# Introduction

## Purpose of this Report

This Response to Submissions Design Report has been prepared by Foster+Partners on behalf of the Pitt Street Developer North Pty Ltd to address the matters raised by government agencies, the public and community organisation groups during public exhibition of the proposed Sydney Metro Pitt Street North Over Station Development (OSD) State Significant Development (**SSD**).

Plan view showing relationship between Park Regis and Proposed Pitt Street North development

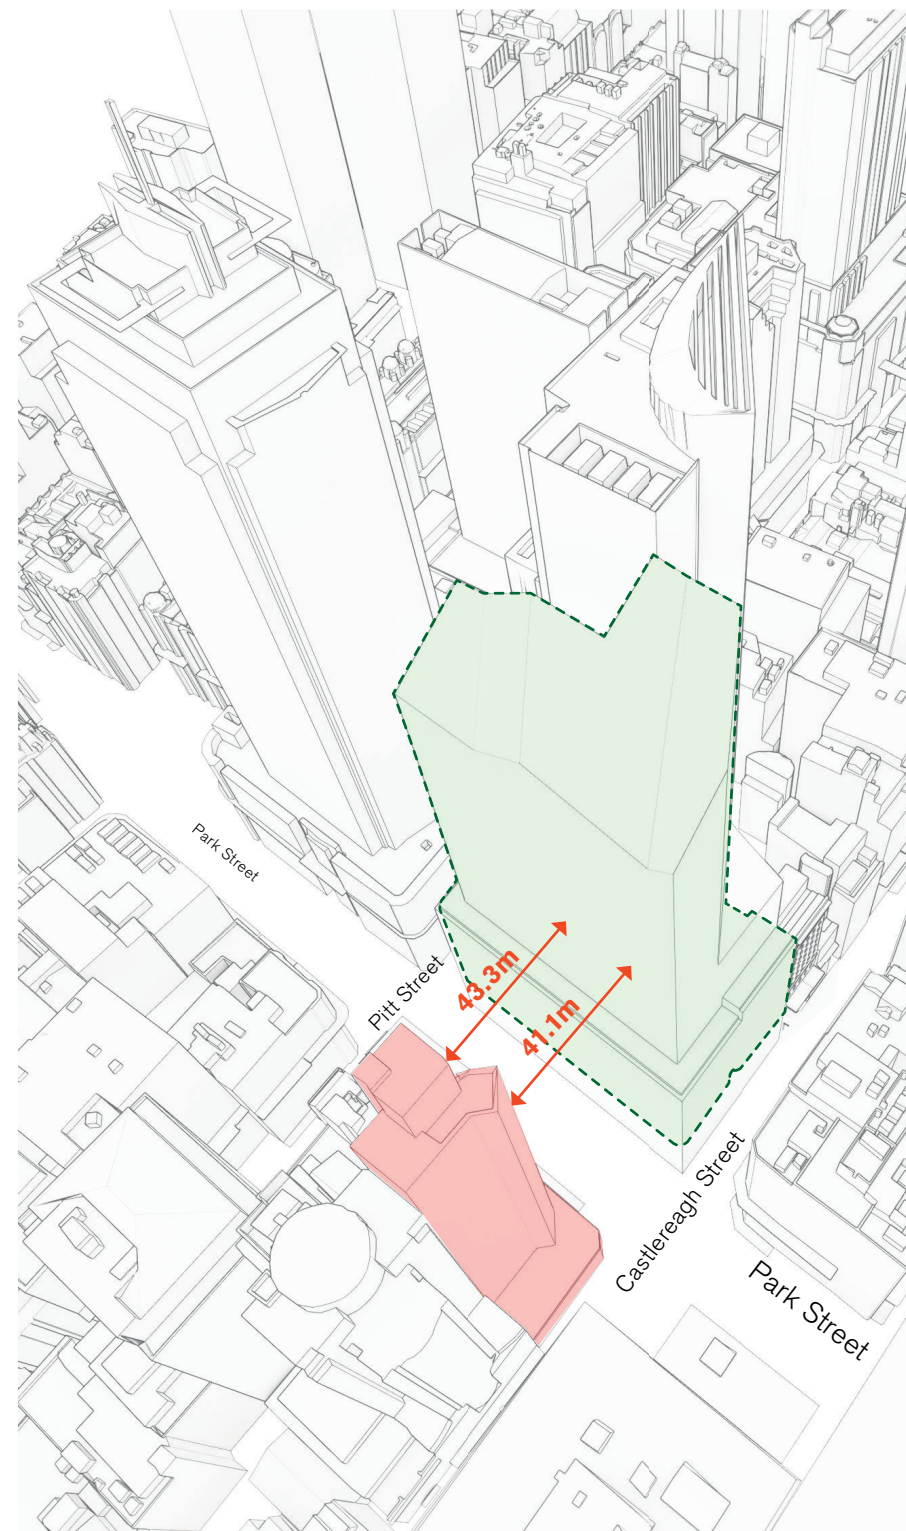
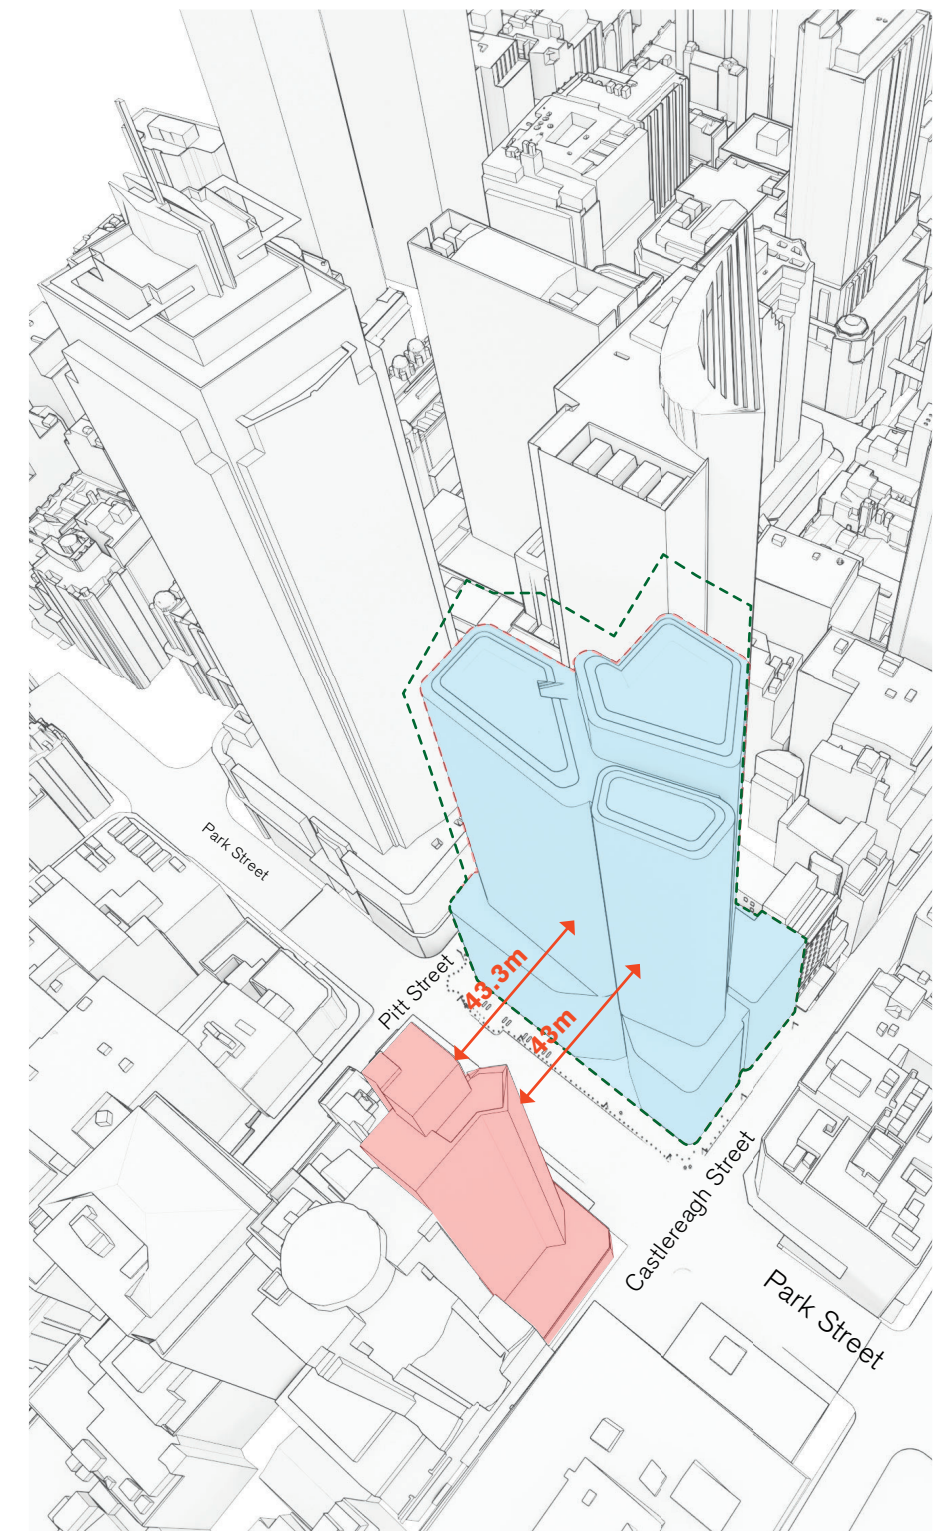
### Park Regis Impact

For further information on overshadowing of Park Regis residential apartments, please refer to Chapter 1.2 of this Rts Design report.

Envelope for a typical Podium level

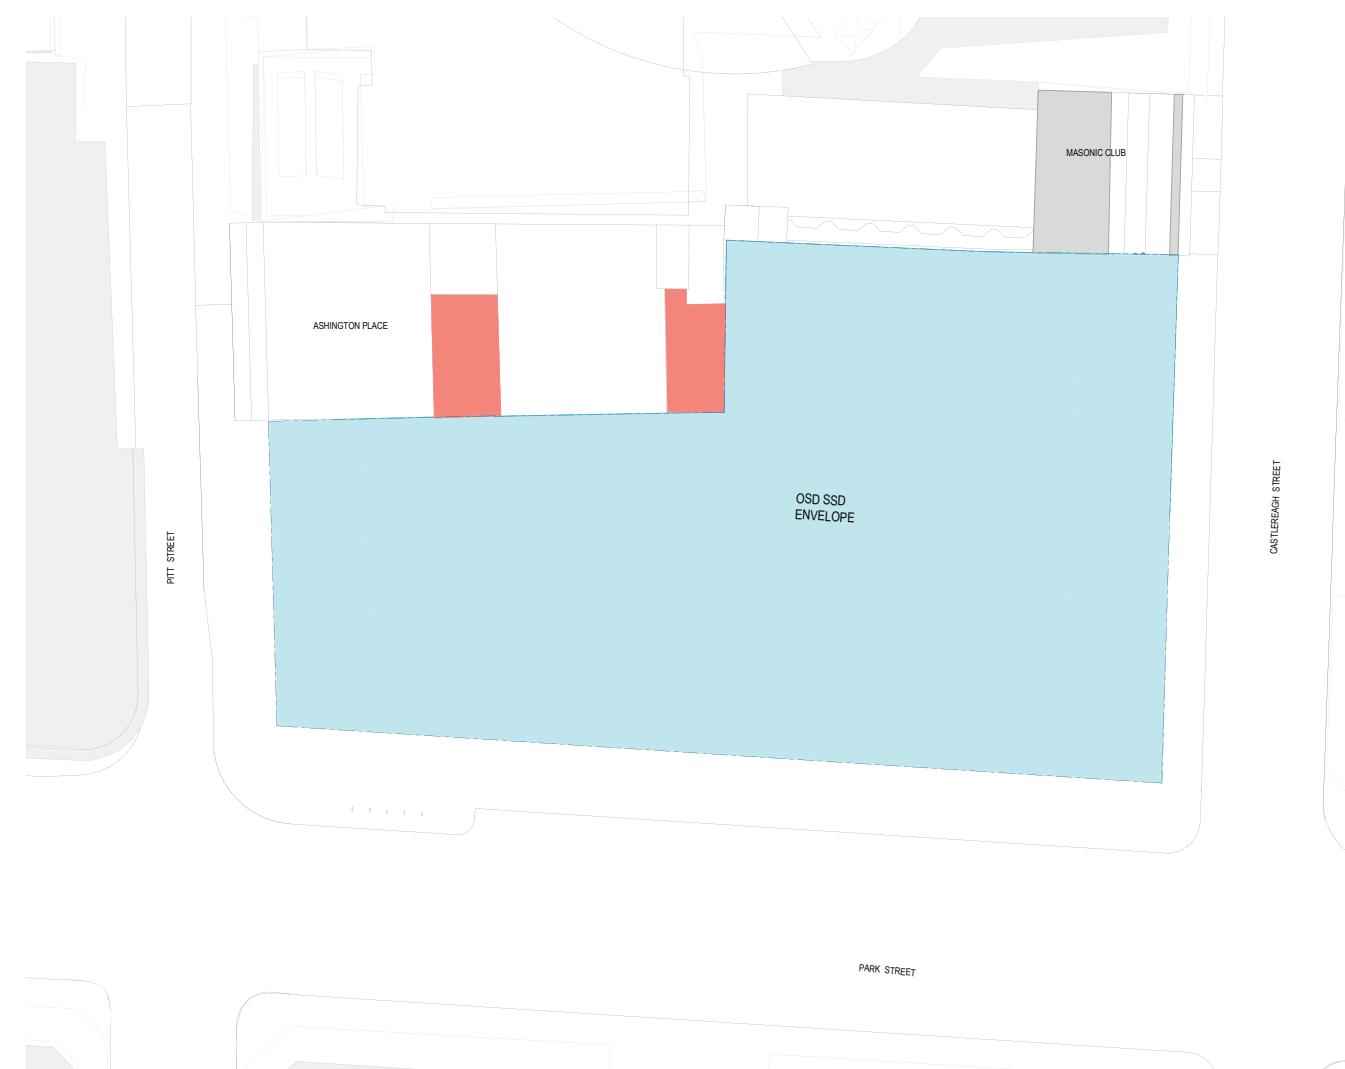
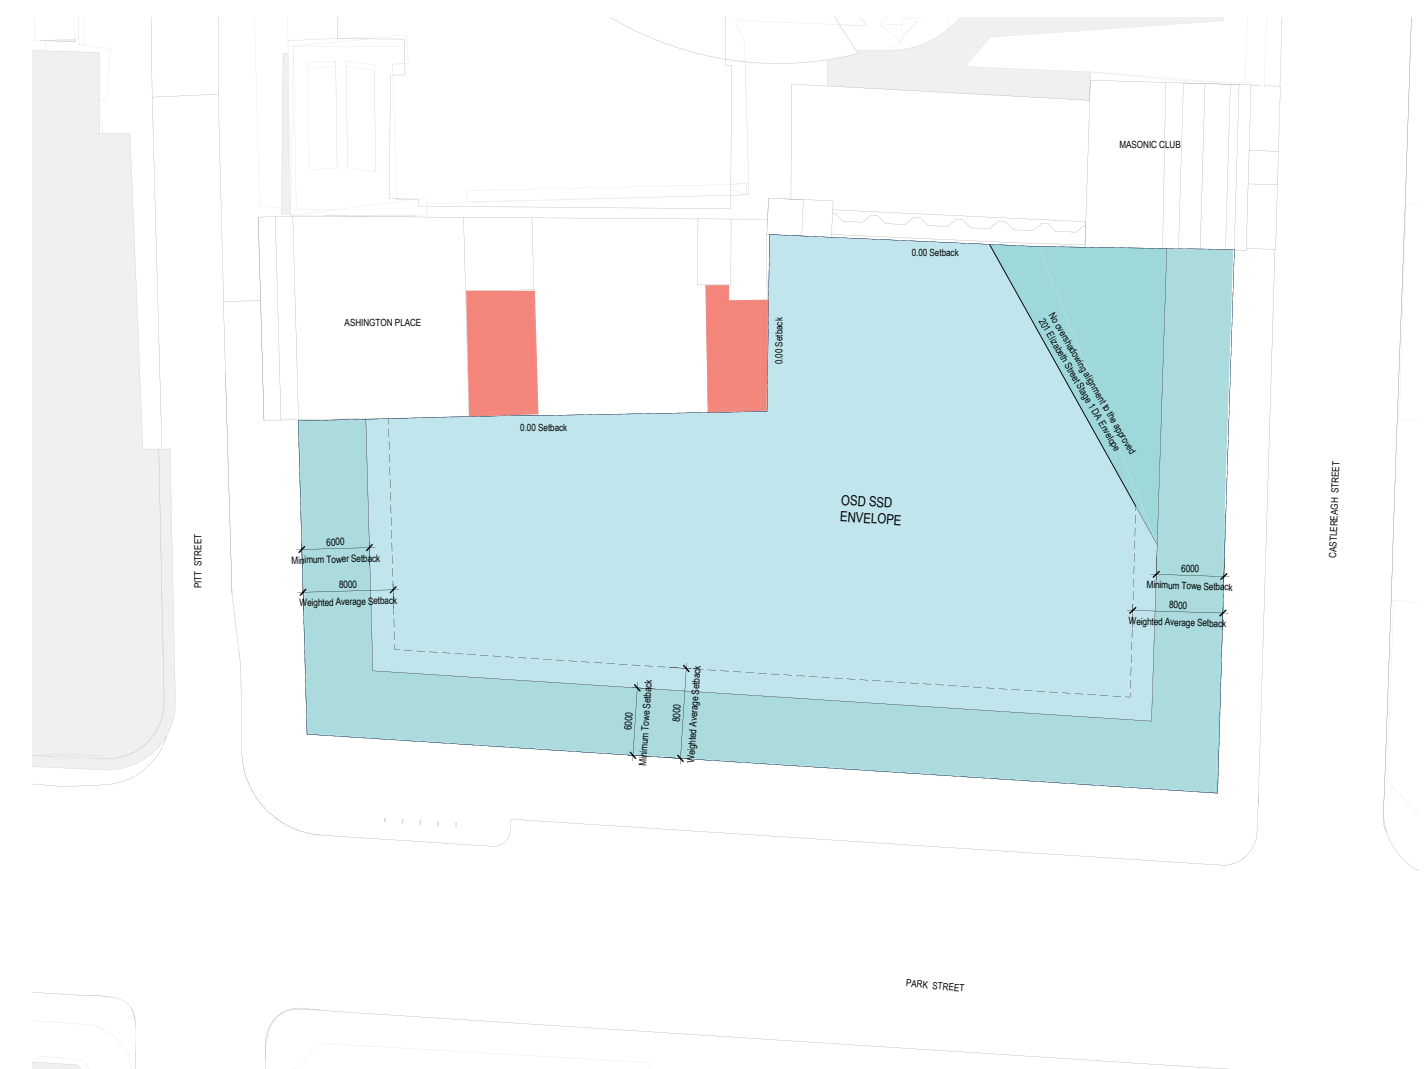
***Raises issue with podium height and sunlight access to the National Building. Increasing podium height to the top of the National Building will block all existing light access to suites on level 1 and 2. Offices on top of podium will further impact sunlight access. The sculptural artwork commissioned by the Owners Corporation of 250 Pitt St, positioned in the light well of 250 Pitt St will no longer be visible to occupants within the National Building.***

The approved Stage 1 Envelope further allowed for a 0m setbacks to the rear boundary for both tower and podium levels, given the adjoining sites heritage significance and inability to develop any higher. As such a change in the datum location between podium and tower will not have any impact on the daylight access to the Ashington Place/ National Building lightwells.

Plan section showing the facade treatment to the Ashington Place / National Building podium lightwells

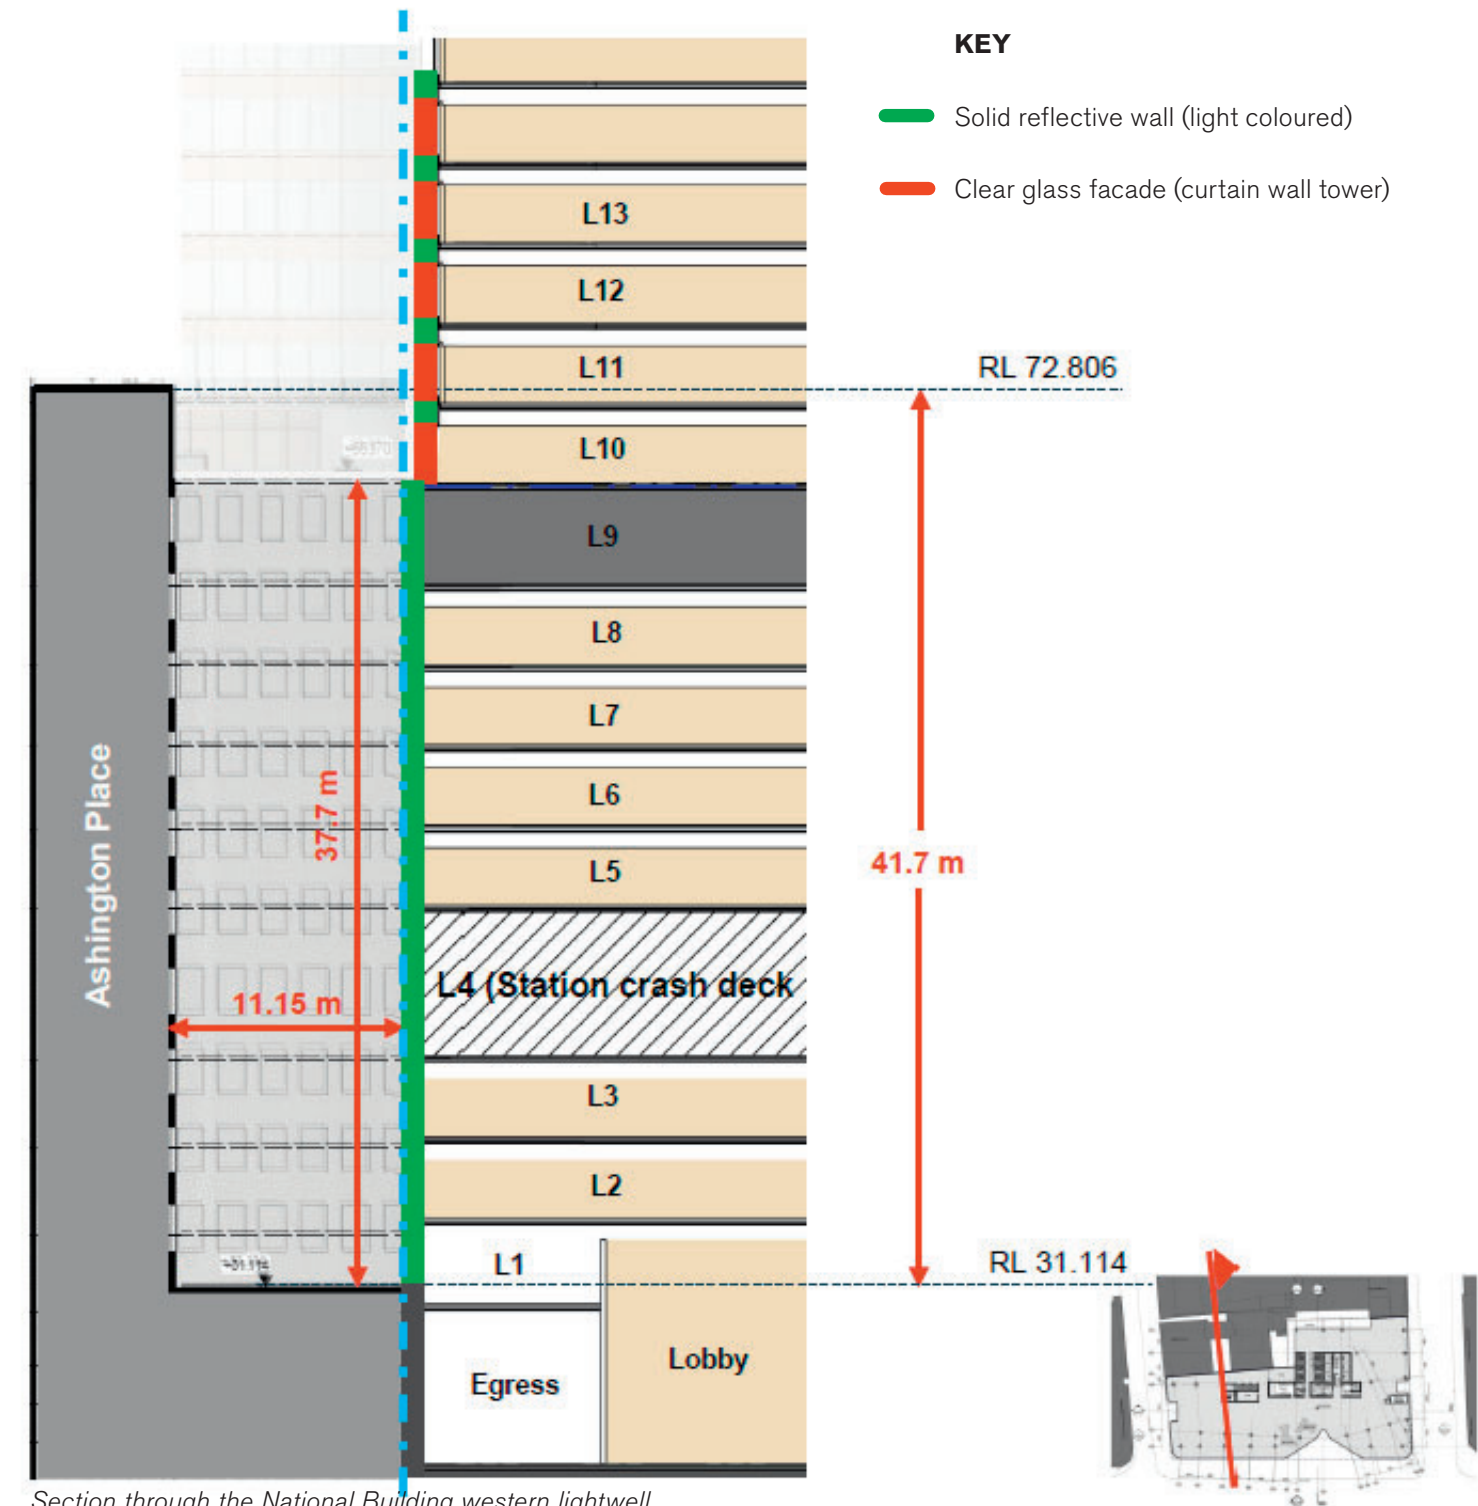
#### Ashington Place lightwell walls & artwork

In the proposed SSDA design, the detailed expression and materiality of the OSD facade facing the Ashington Place lightwell fully complies with the project requirements established in the OSD North Design Parameters during the RFT phases of the project.
